TITLE: ATmega328 Soldering Station / T12 Tips	REV: 1.0
嘉立创EDA	Company: HM Projects
	Sheet: 1/1
	Date: 2022-12-23 Drawn By: Valentin S.

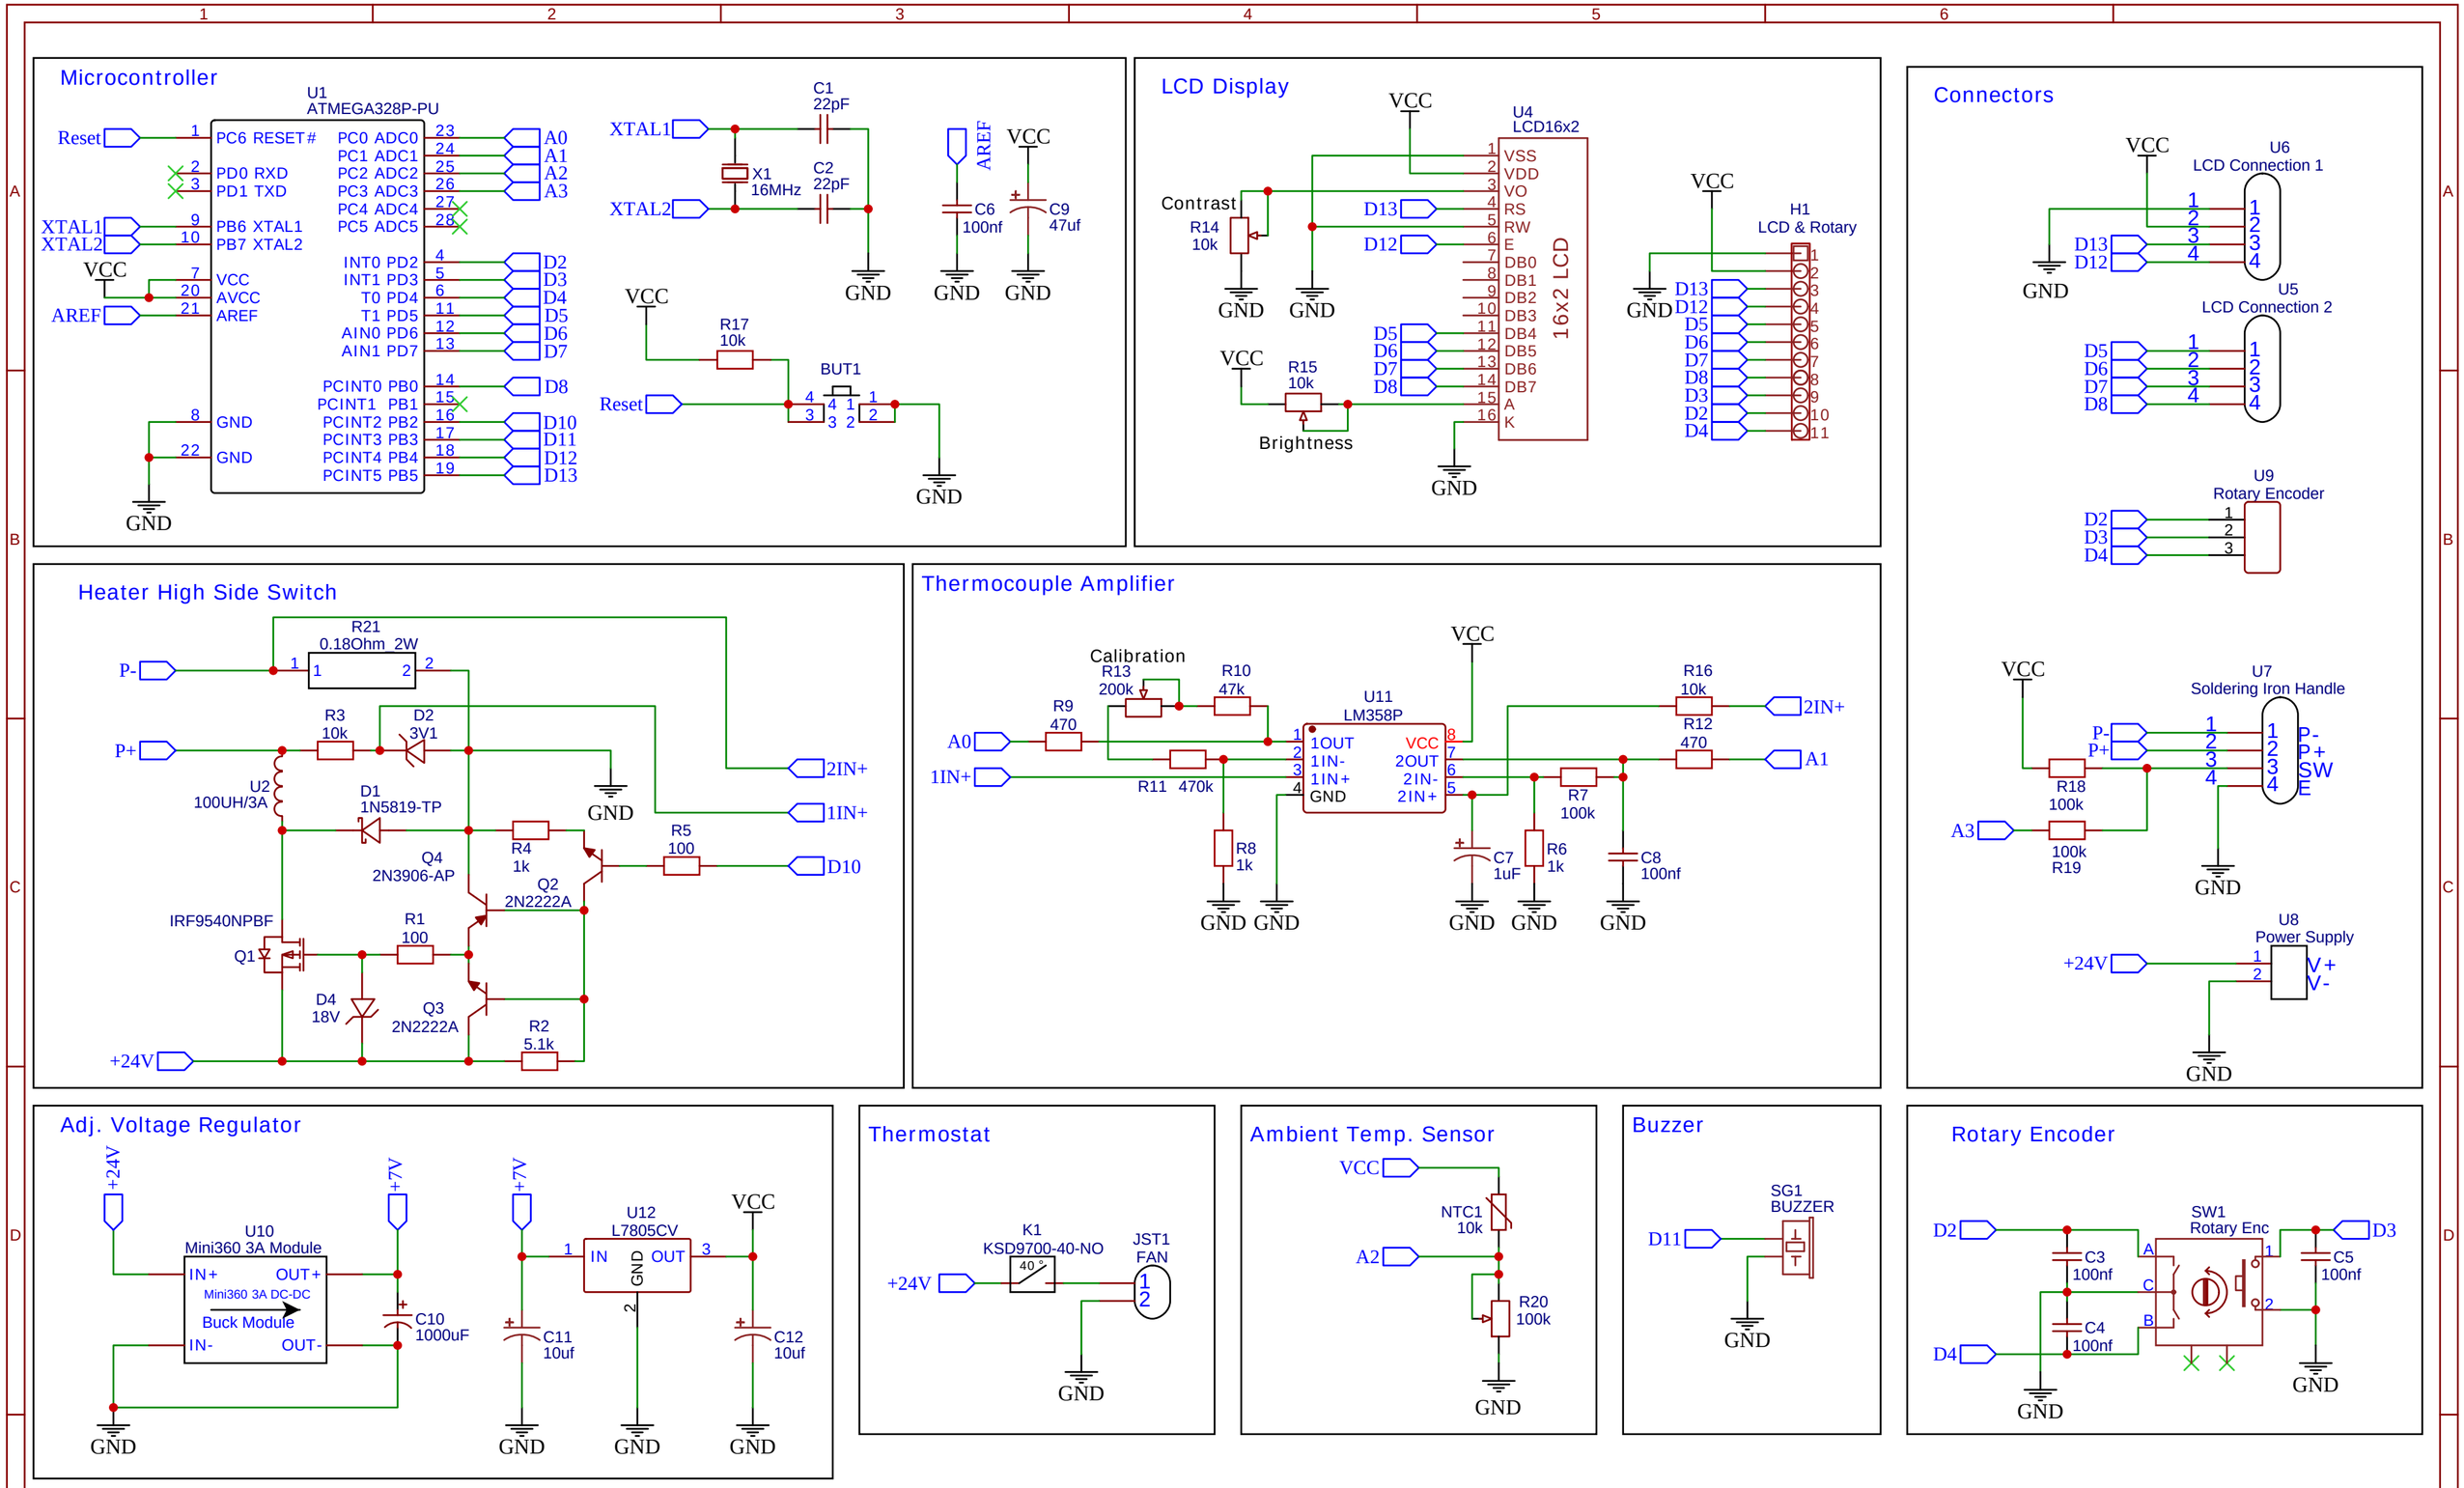
The LM358P is not rail to rail Operational Amplifier is better to be replaced with AD822 or MCP602 which can provide more stable and accurate temperature measurements.
